Client LB Camden	Job Name Agar Grove	Job No. 1237
Title Plot G Fifth Floor Plan	Status Planning	Scale 1:100
Drawn By MD	Checked By JH	Date 29.08.14
Drawing No. 1423_DWG_PL_G_00_205	Revision B

Client	LB Camden
Job Name	Agar Grove
Job No.	1237
Title	Plot G Roof Plan
Status	Planning
Scale	1:100
Drawn By	MD
Checked By	JH
Date	29.08.14
Drawing No.	1423_DWG_PL_G_00_206
Revision	B

Client	LB Camden
Job Name	Agar Grove
Job No.	1237
Title	Plot G Elevation West
Status	Planning
Scale	1:100
Drawn By	MD
Checked By	JH
Date	29.08.14
Drawing No.	1423_DWG_PL_G_00_252
Revision	A

Key Section AA 1:250 @ A1

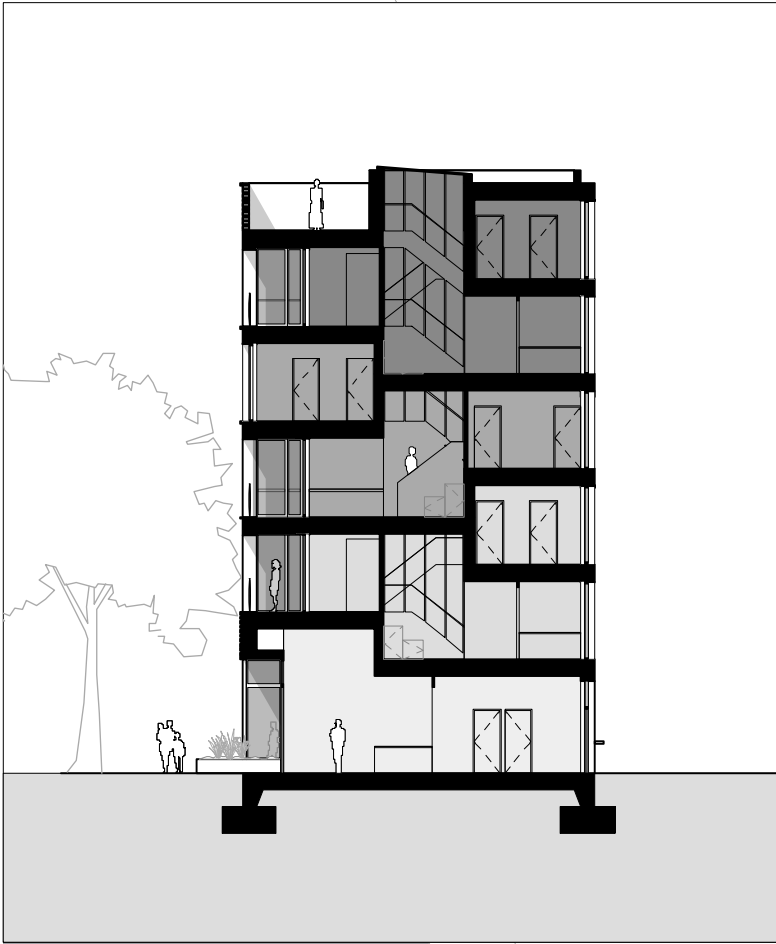
Staircore reconfigured; external cladding changed to Rheinzink

01 West elevation

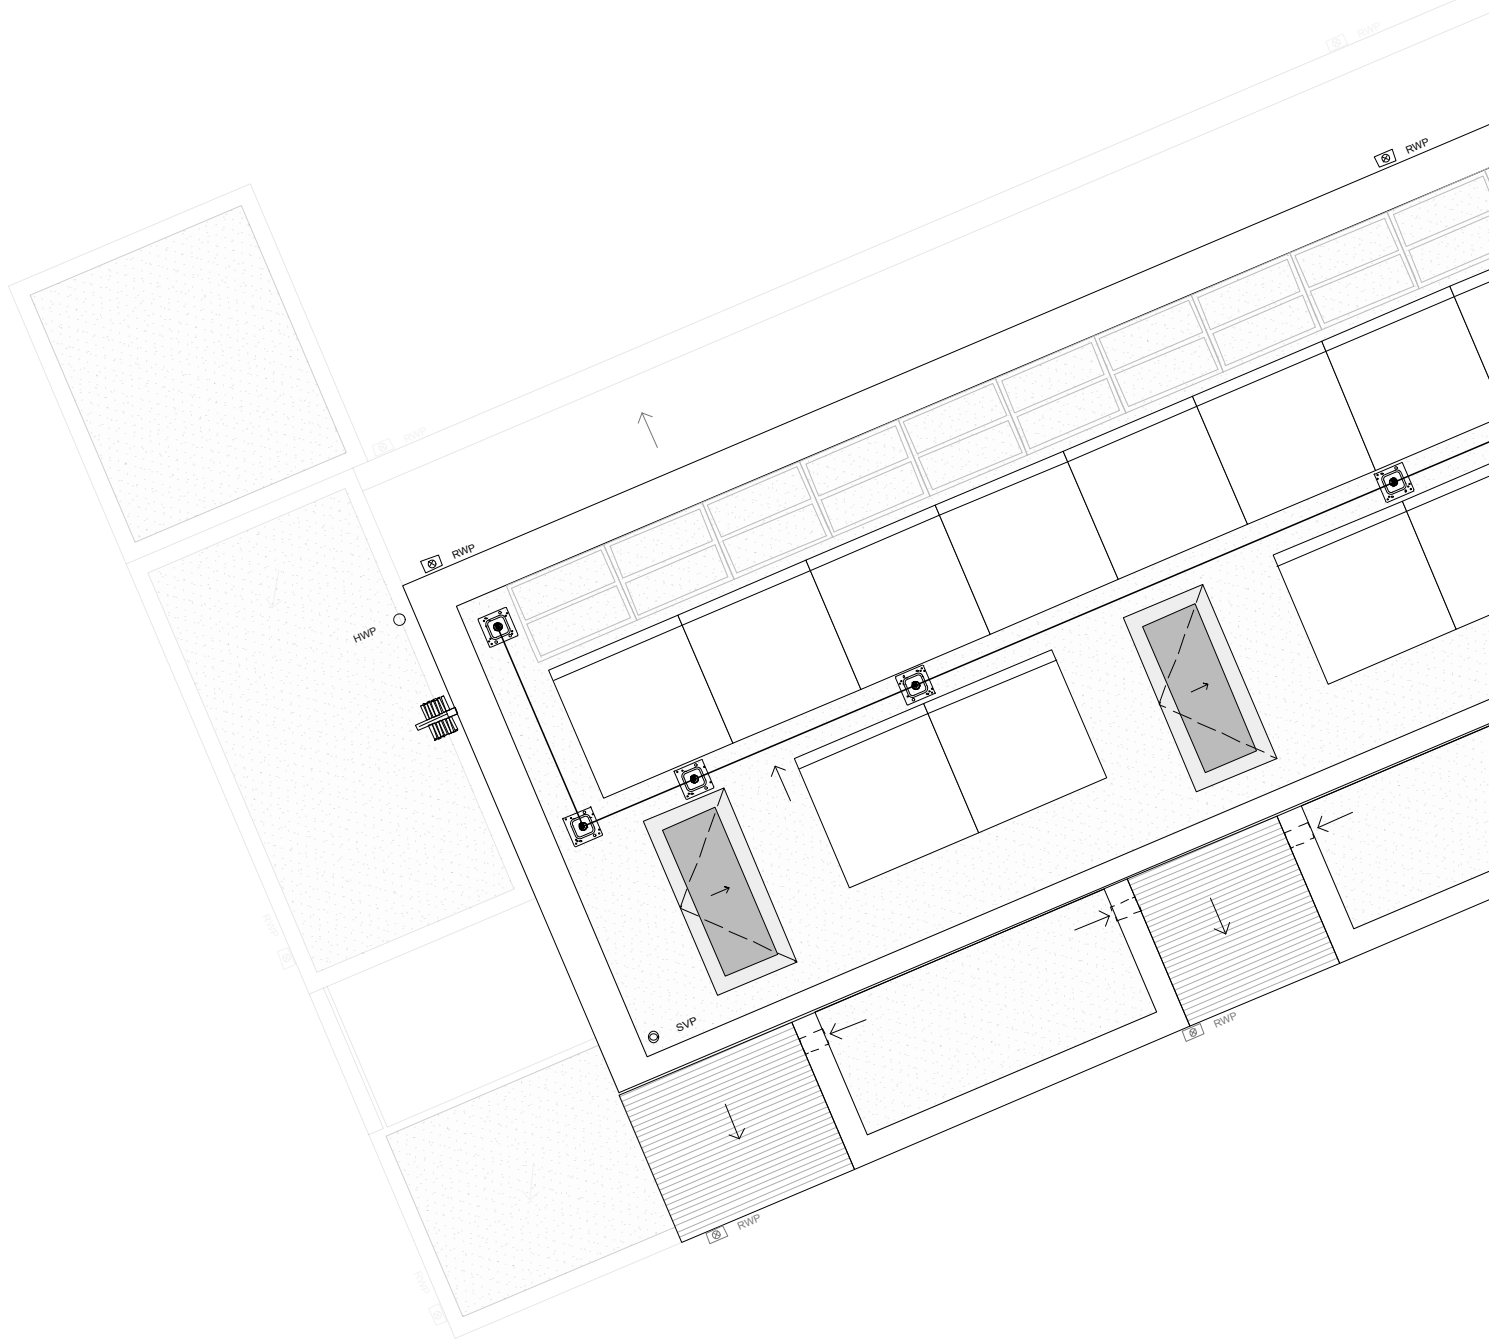
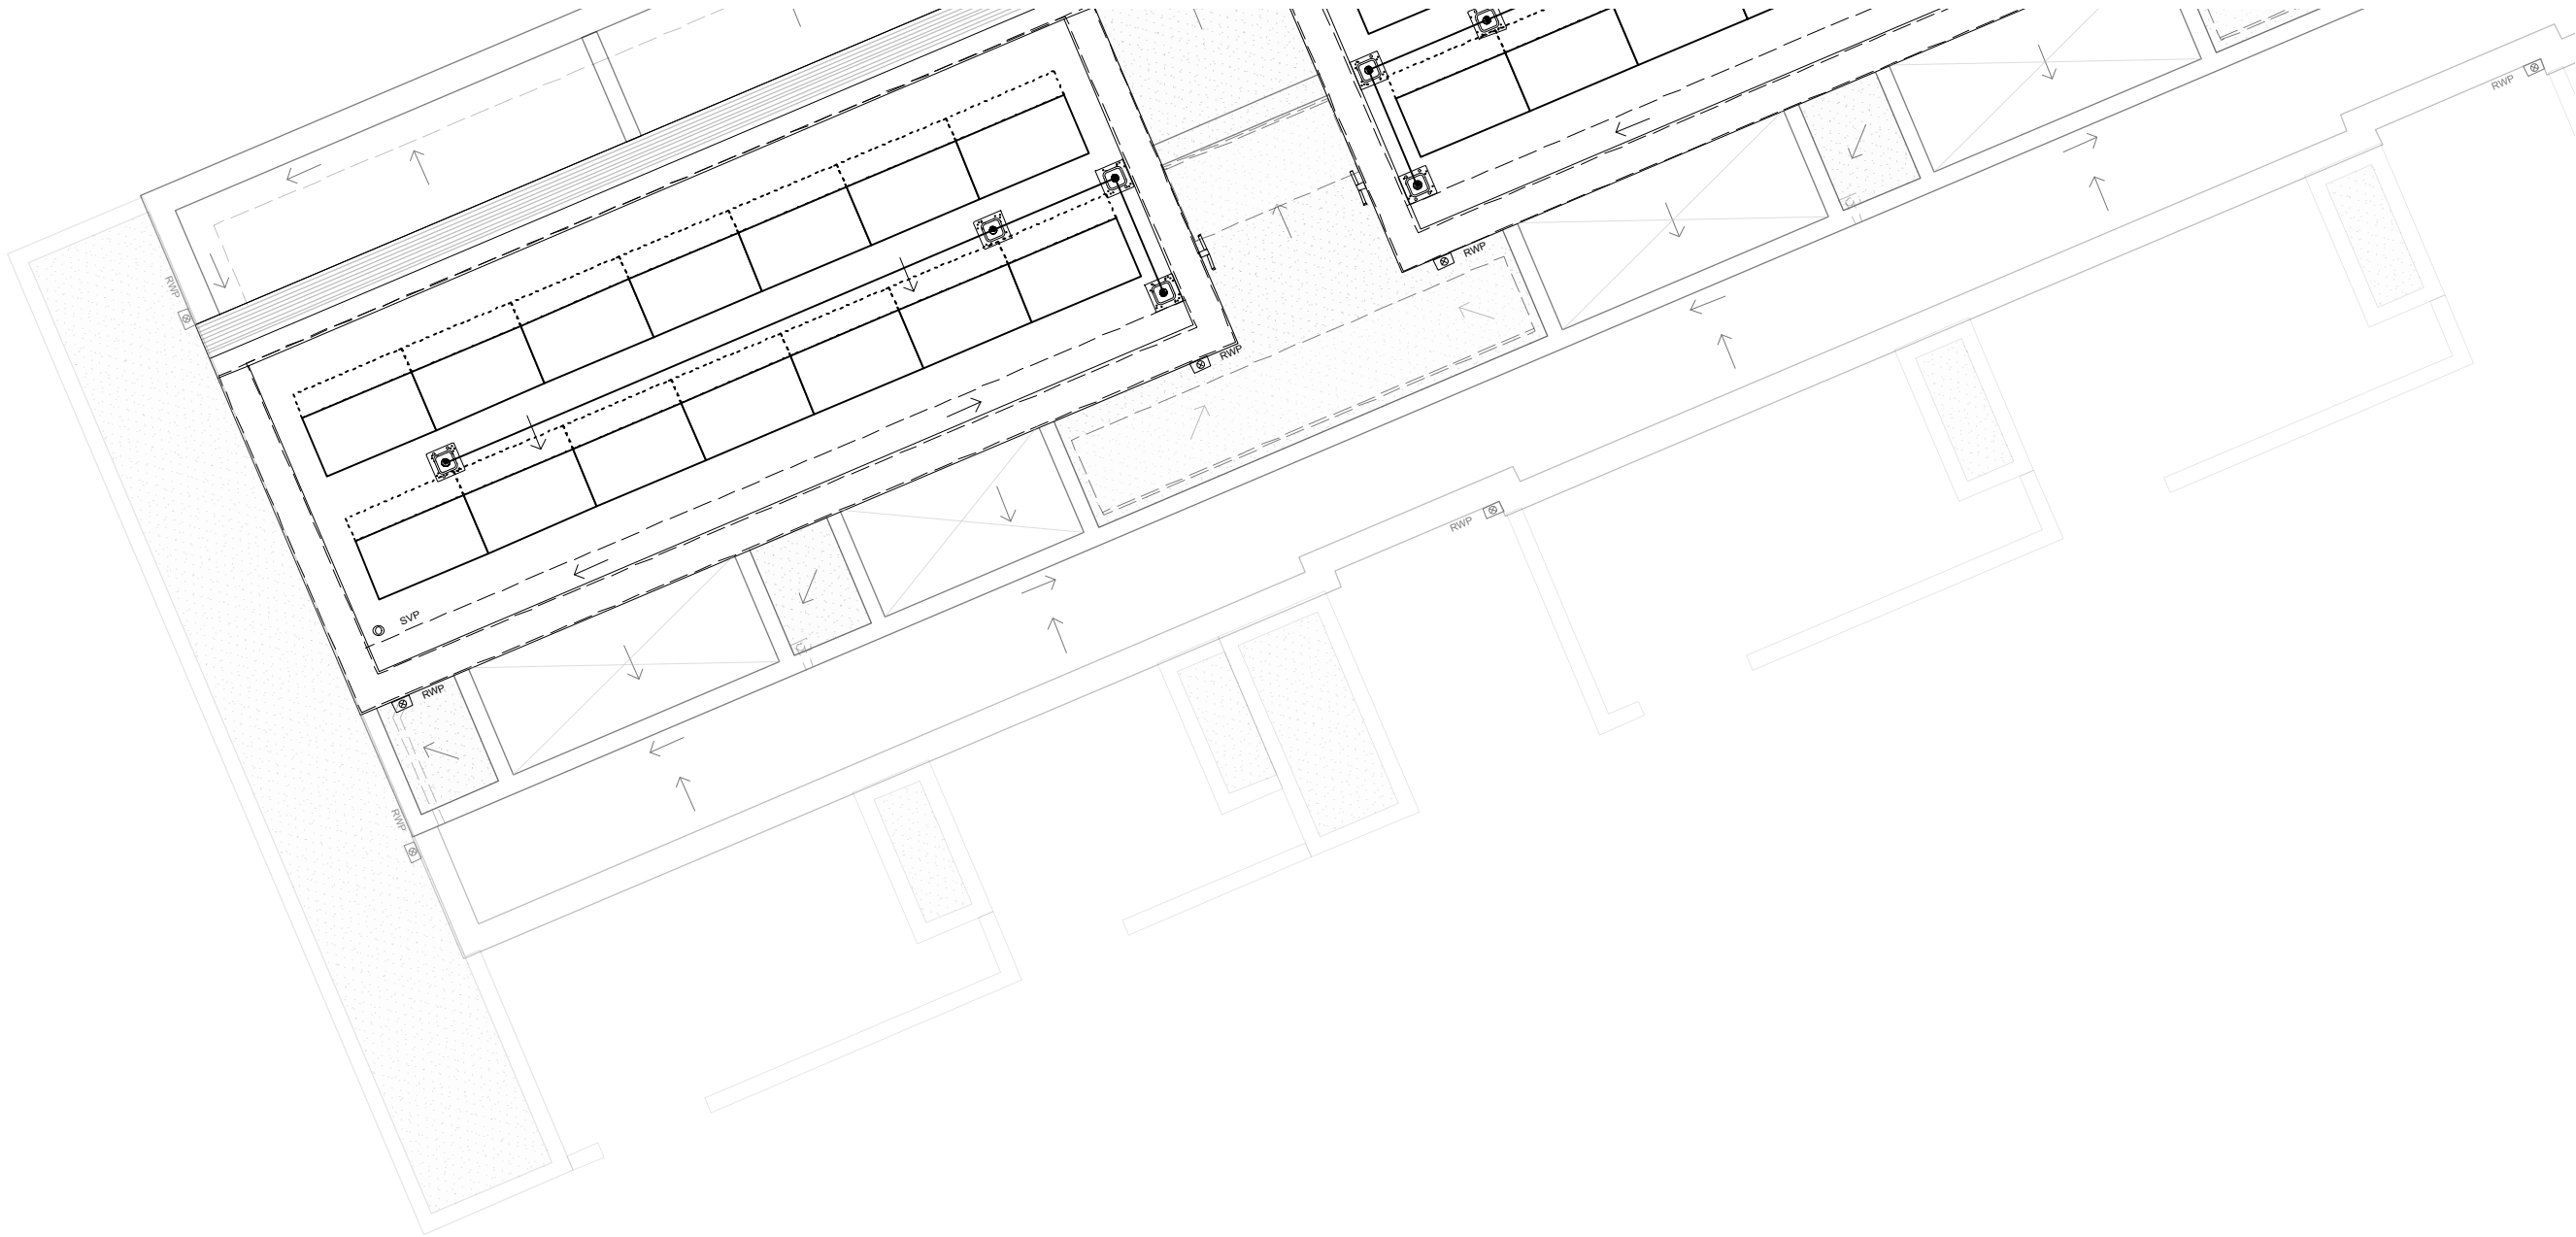
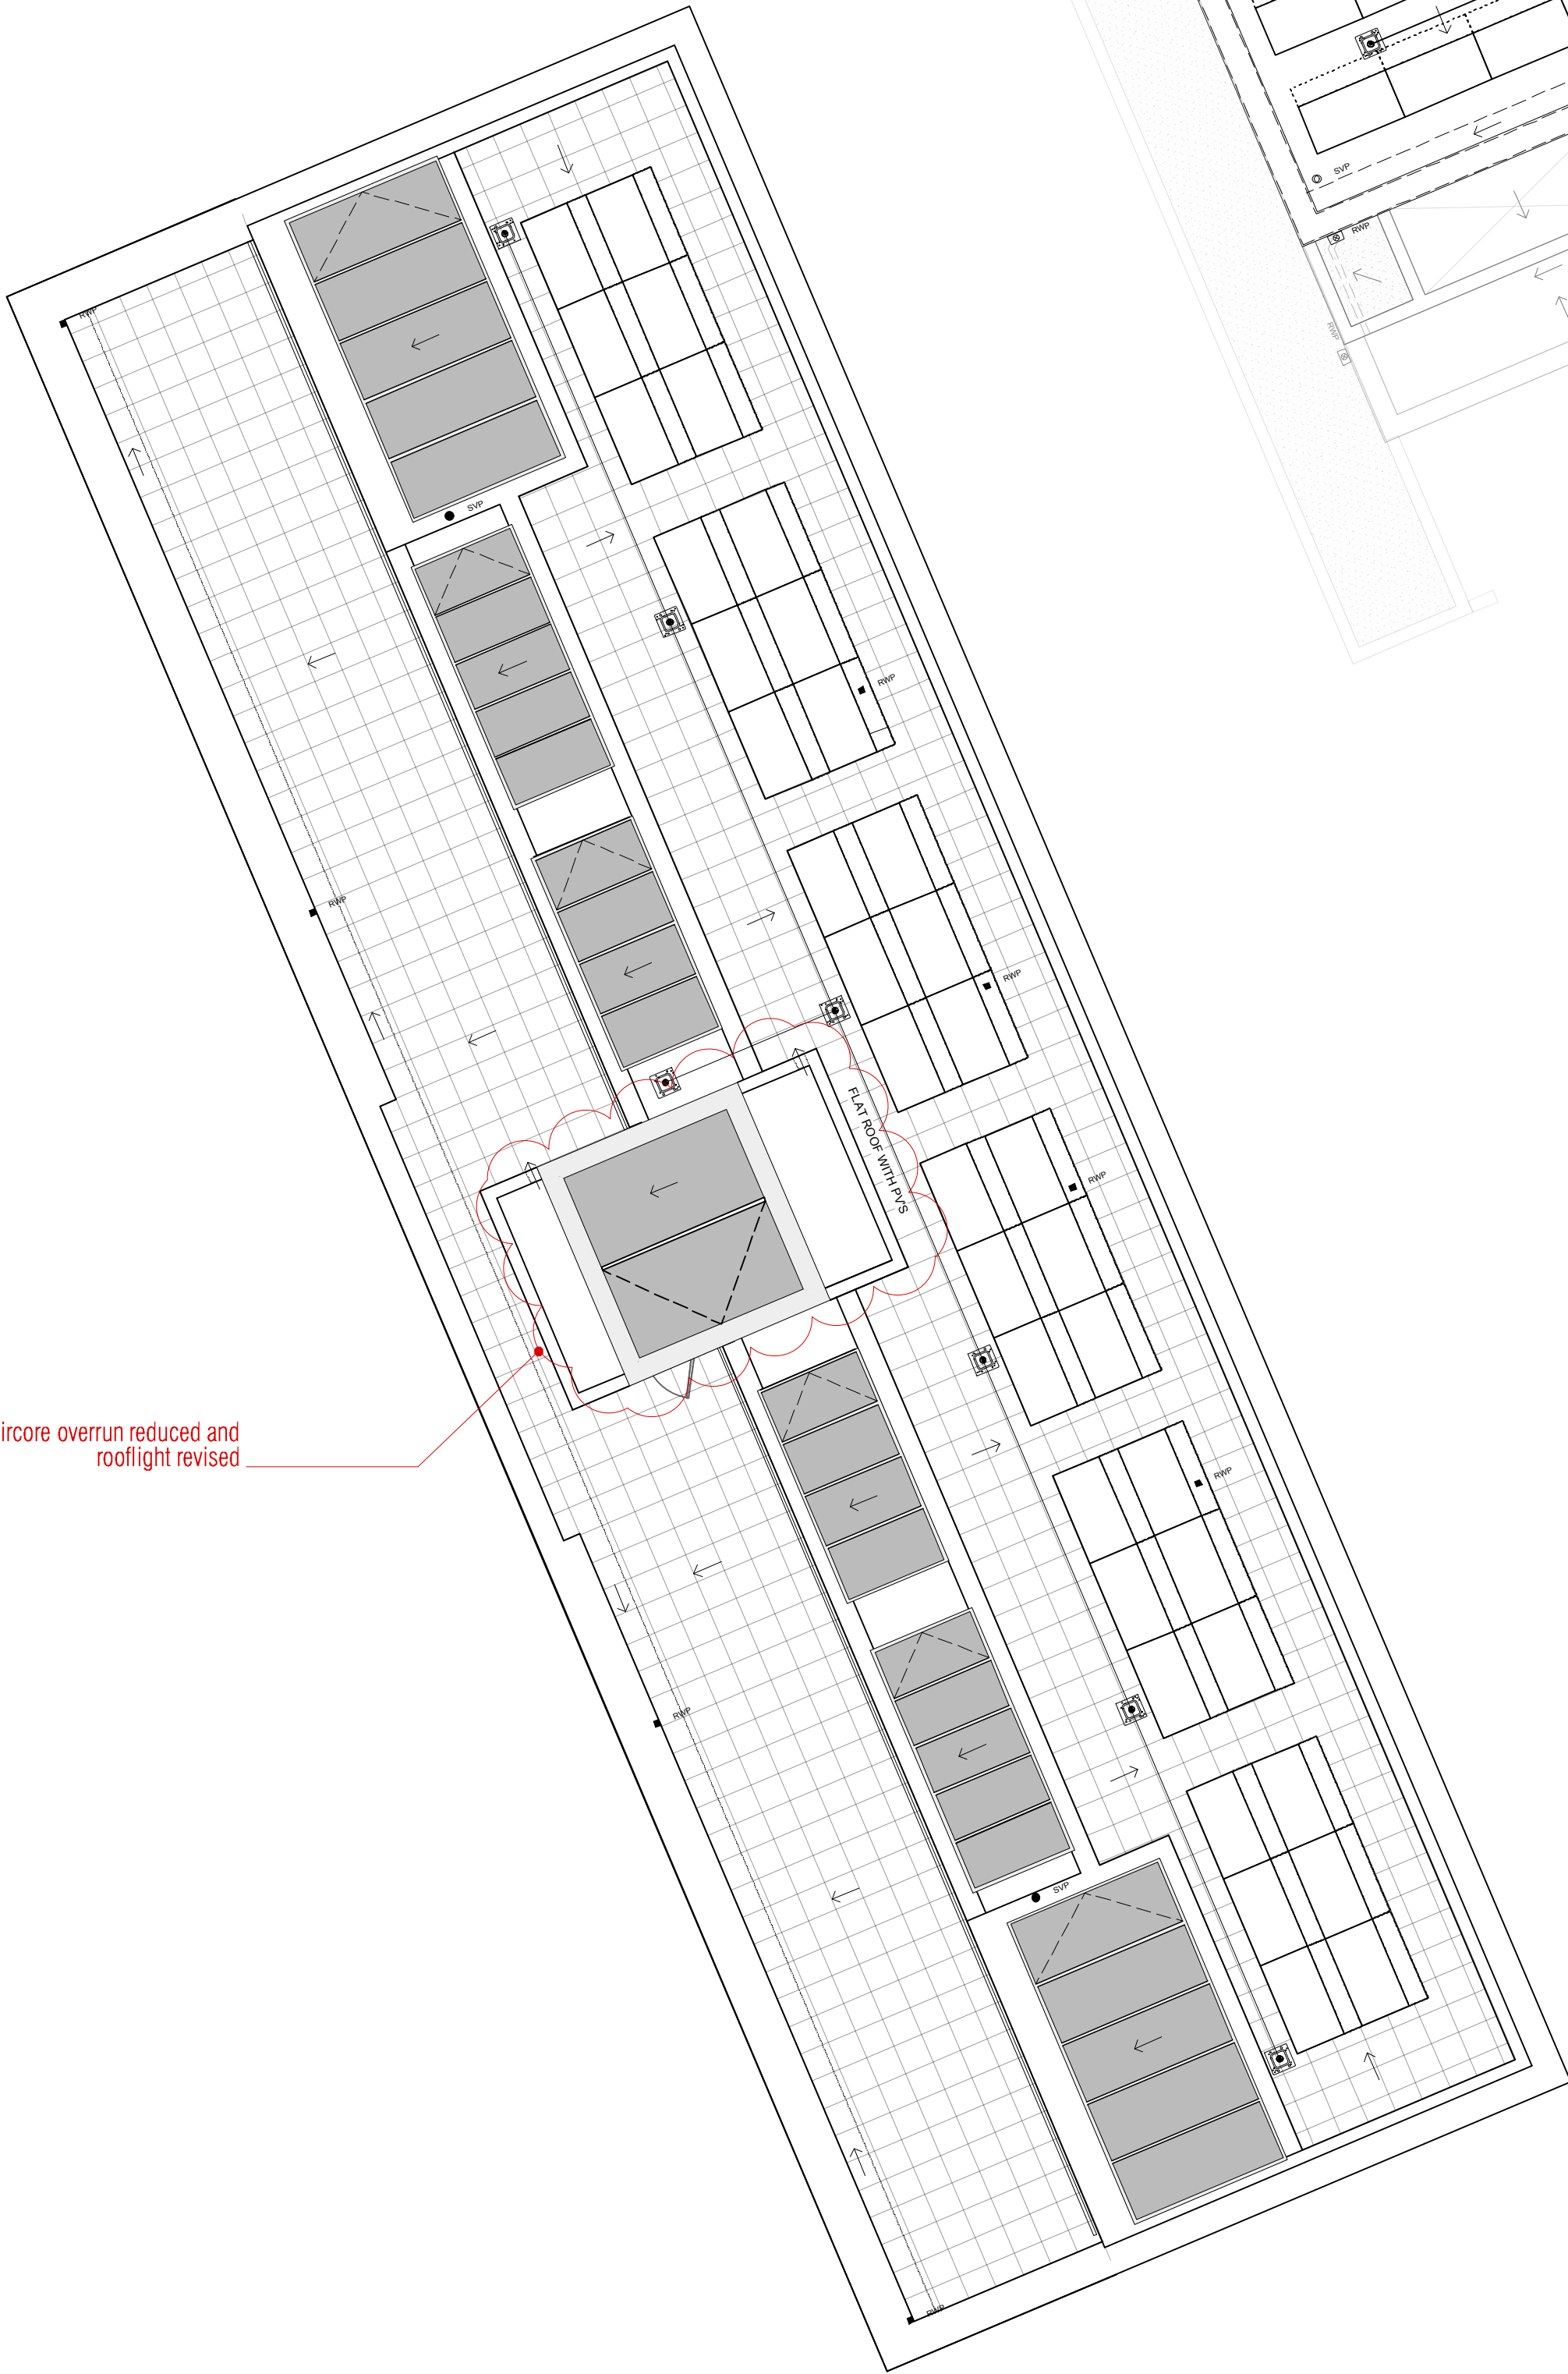
Rear deck made continuous and elevation windows revised
